# Location C/D

MAP-24-65 City of Detroit Petition DTE Electric Dimensions

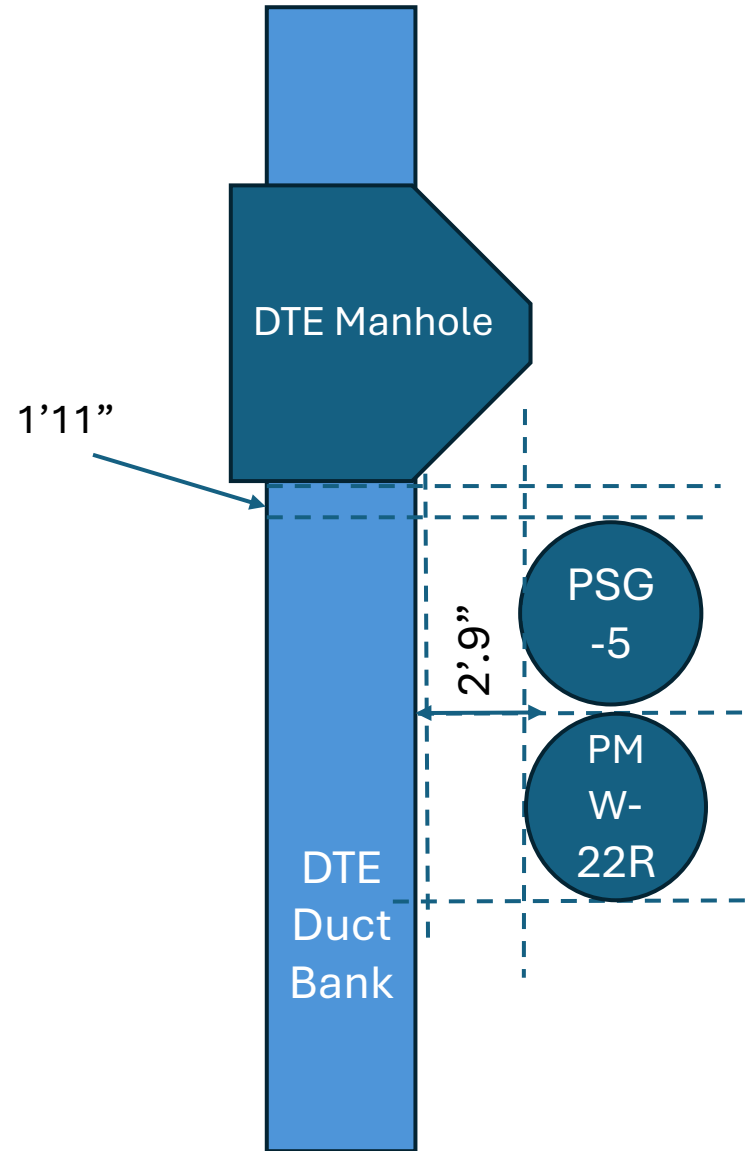
2'9" is based on measurement from east edge of DTE manhole to west edge of PMW-22R/PSG-5 . The 2'9" measurement should be increased to 5' for DTE to approve.

\*If different location is identified, DTE will need to re-evaluate.
